SUMMERVILLE HIGH SCHOOL
EXPANSION & RENOVATIONS
SUMMERVILLE, SOUTH CAROLINA

APPROVED
COMMISSION
94071.05

ENCL. A - MARKUP Asbuilts

A101

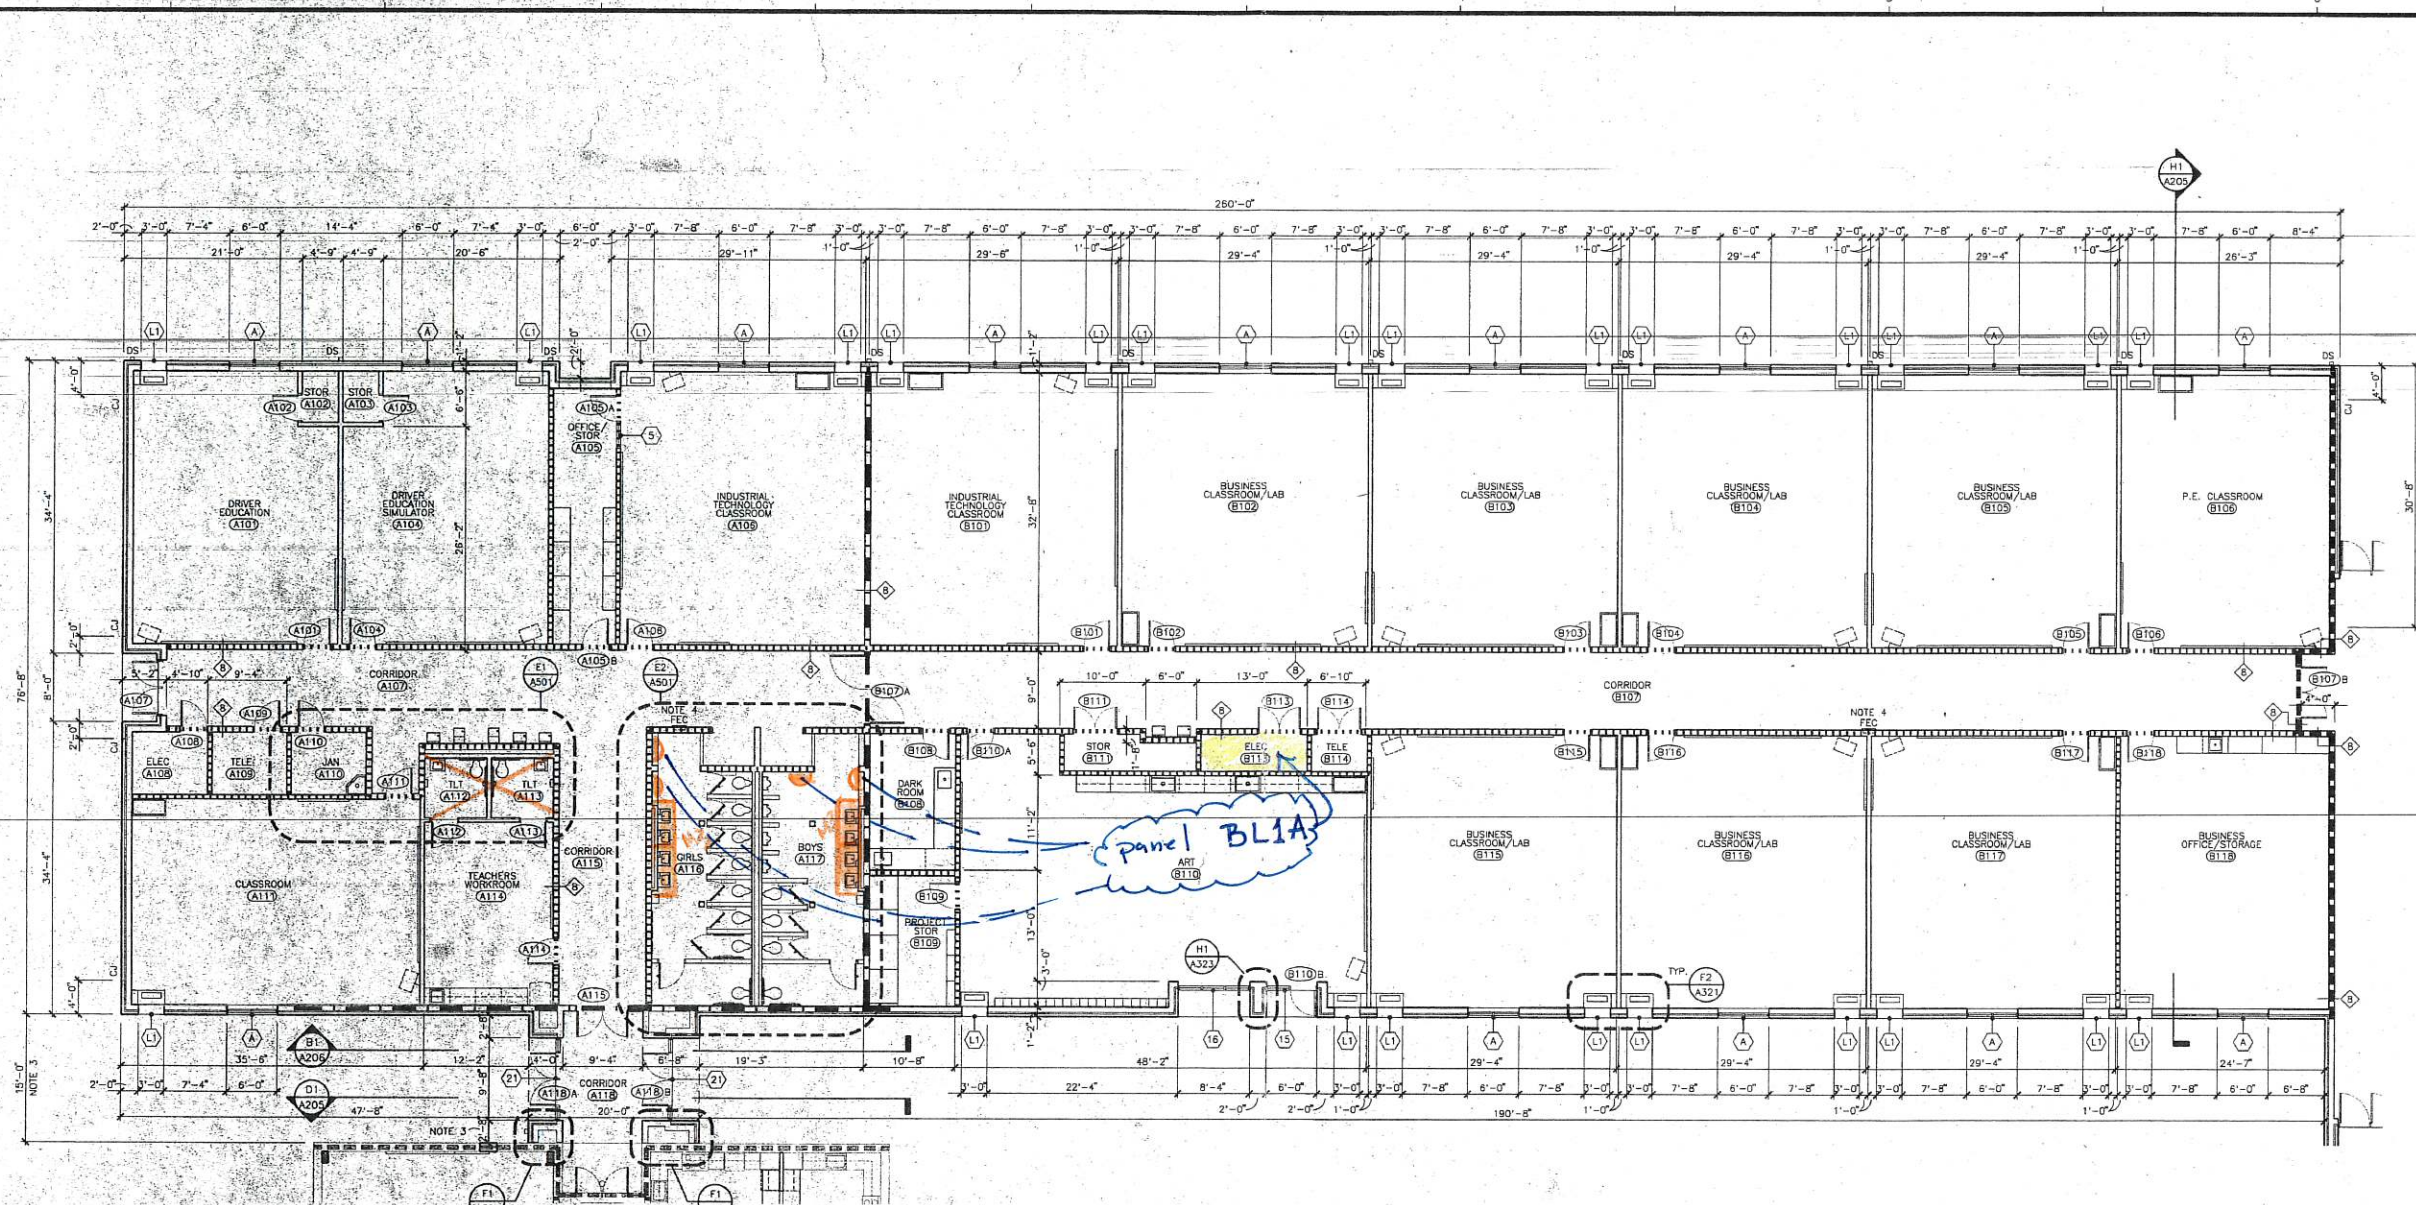
SHEET A101: Make the following revisions:
a. Add concrete splash blocks at all down spouts on east side of Areas A & B.

PARTIAL 1ST
FLOOR PLAN
AREAS D,
E, F &
ALT 2
A103

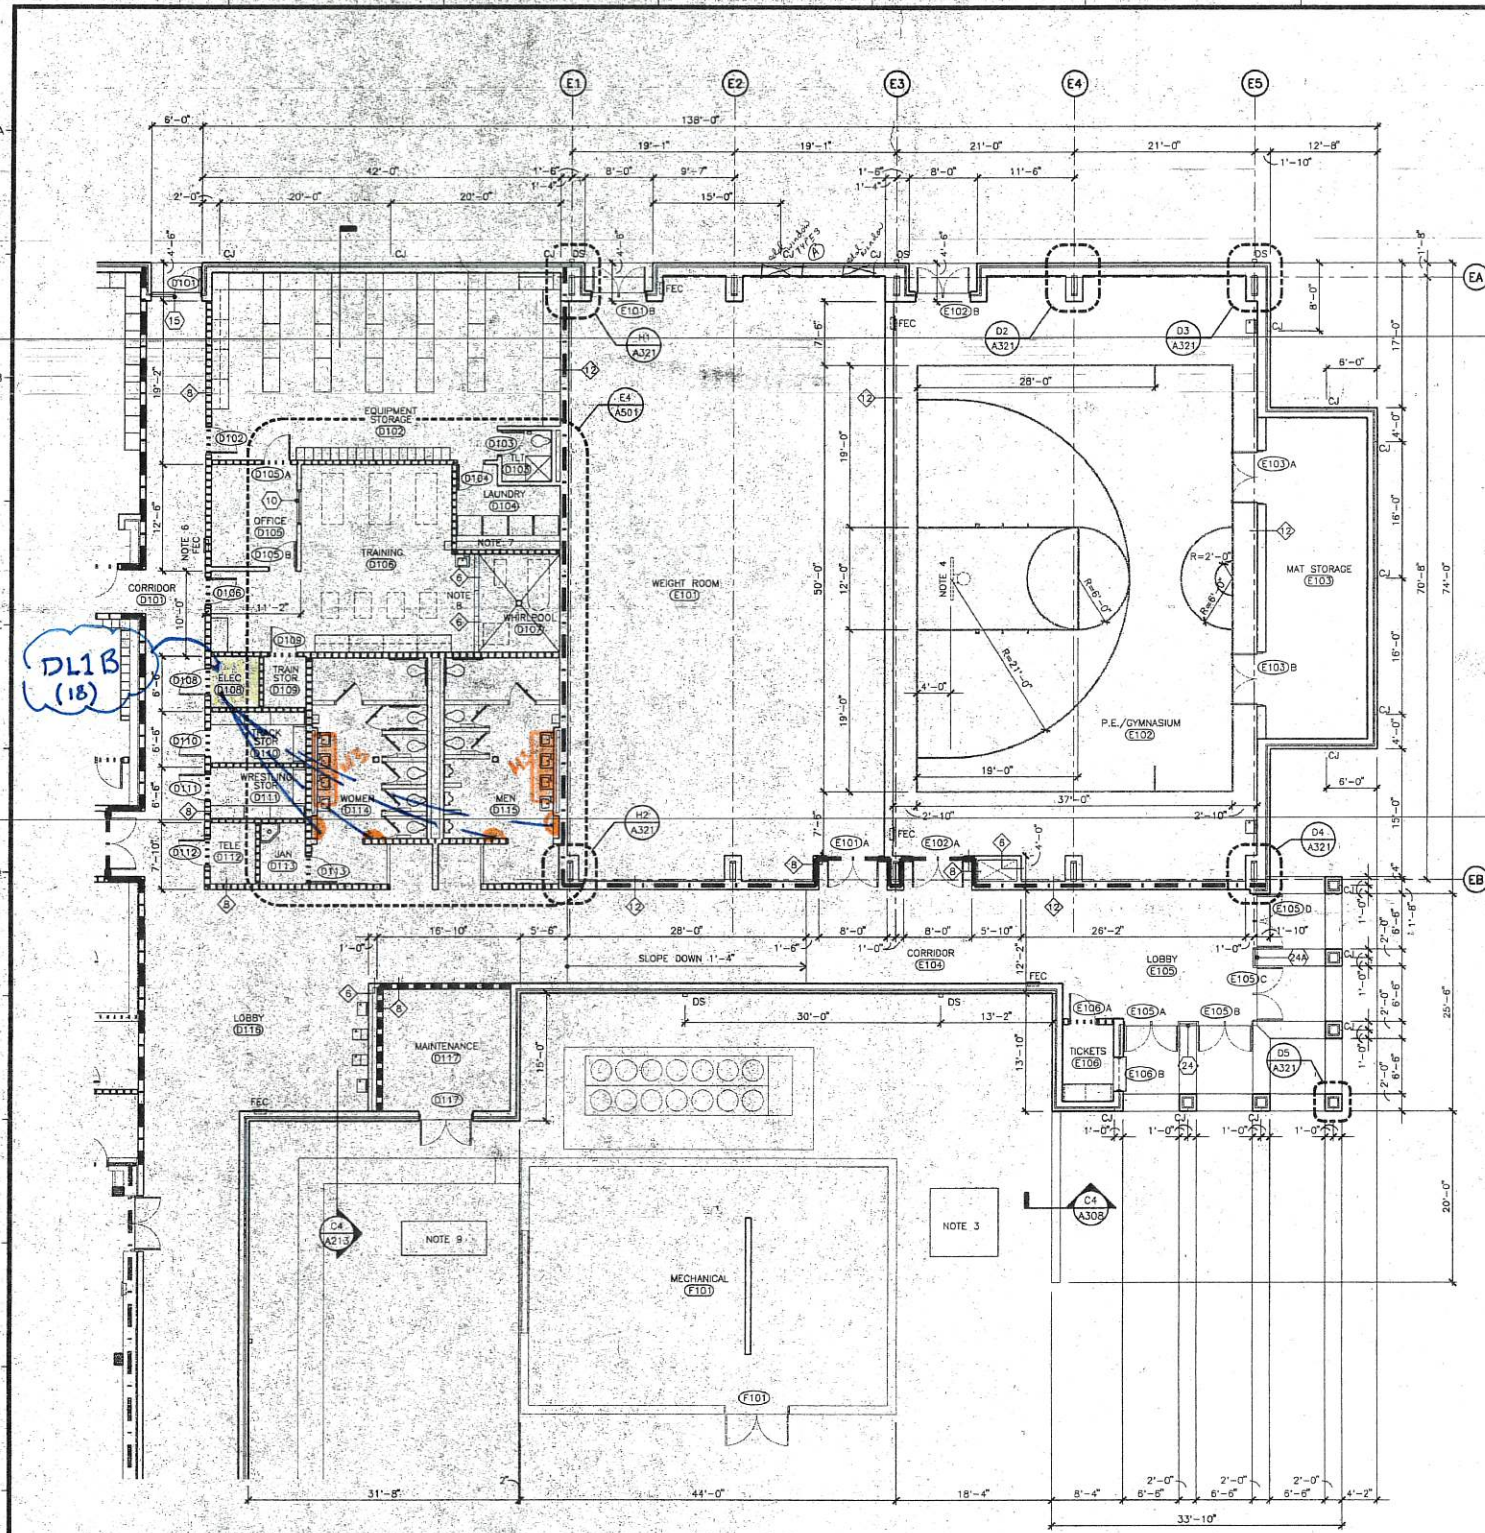
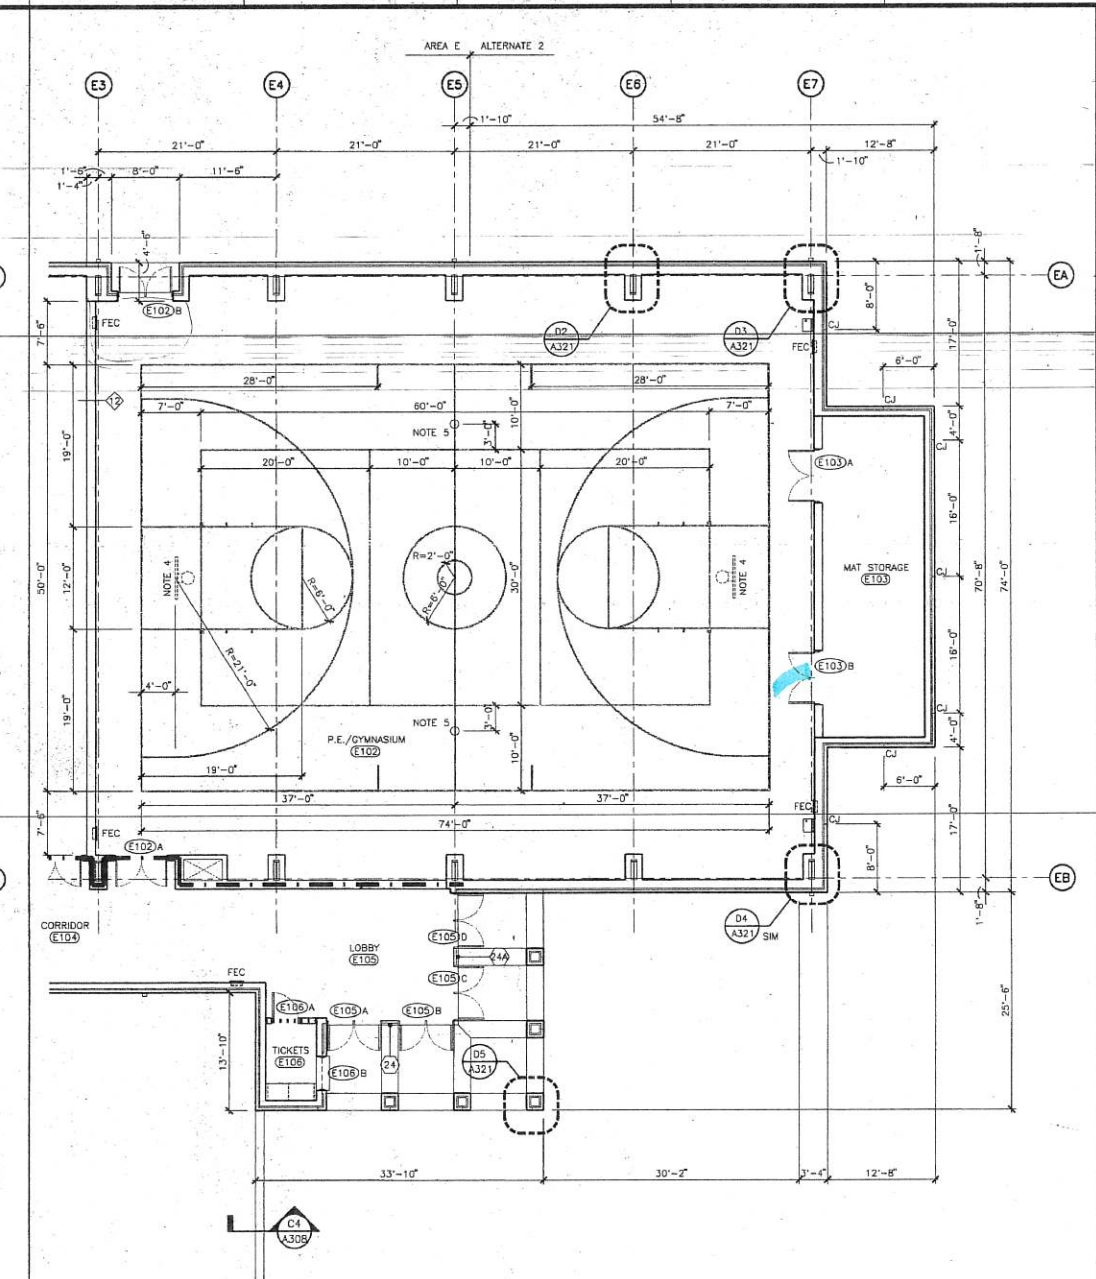
SHEET A103: Make the following revisions:

- Add 6" clear x 6" clear chase (partition type 4) in Northeast corner of Training D106.
- Detail C4 - add 2'-6" x 4'-4" clear chase adjacent to DOOR E102 B (partition type 6) in PE Gymnasium E102 (Alt. 2 only).
- Clarify new partition at MECH. F101 as partition type 5 and top of wall as 7'-4".
- Add concrete splash blocks at all down spouts on east side of Area E and Alternate 2.

APPROVED
COMMISSION
94071.05
PARTIAL 1ST
FLOOR PLAN
AREAS G
& H
A104

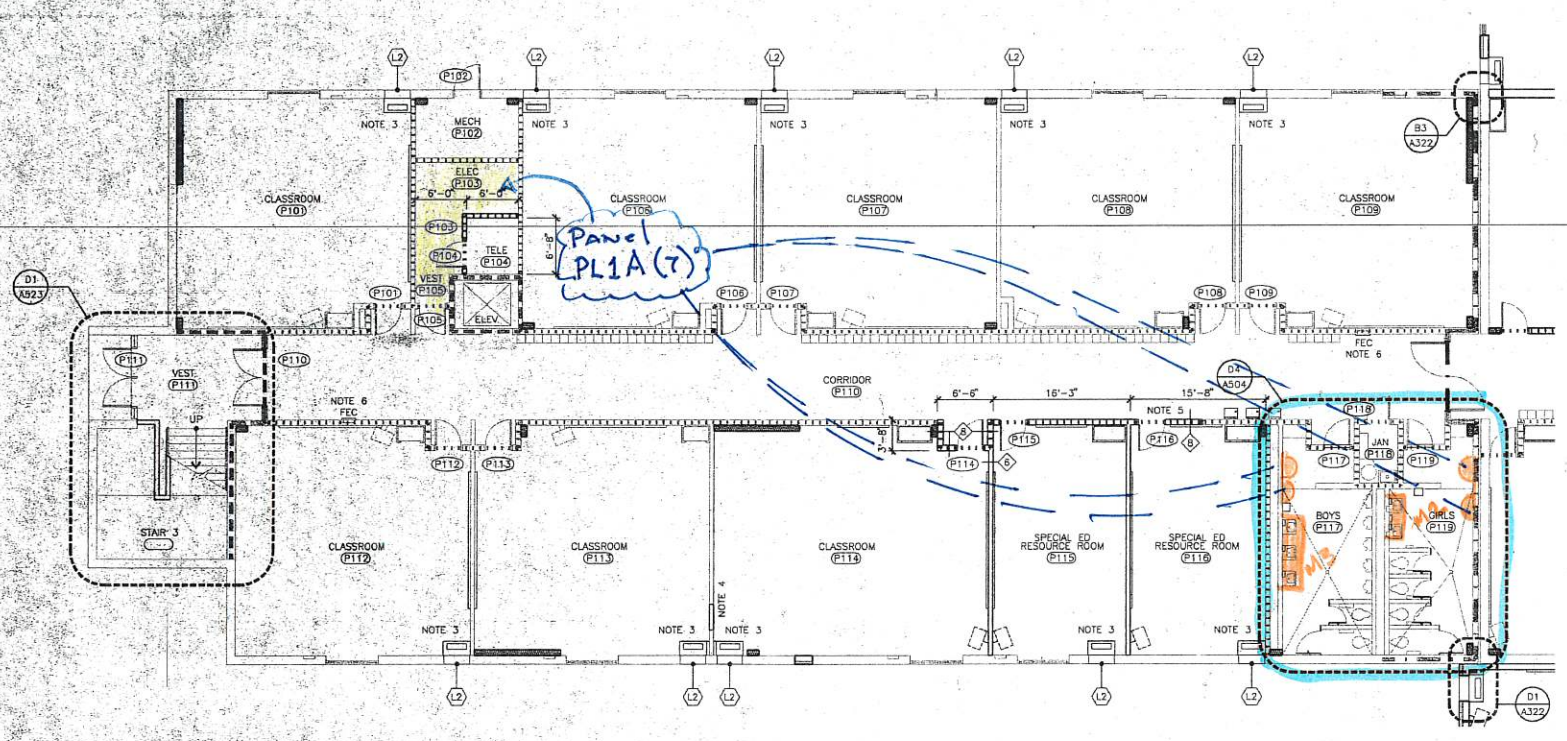
SHEET A104: Make the following revisions:
b. Show floor drain in MECH. G119 to coordinate with plumbing.
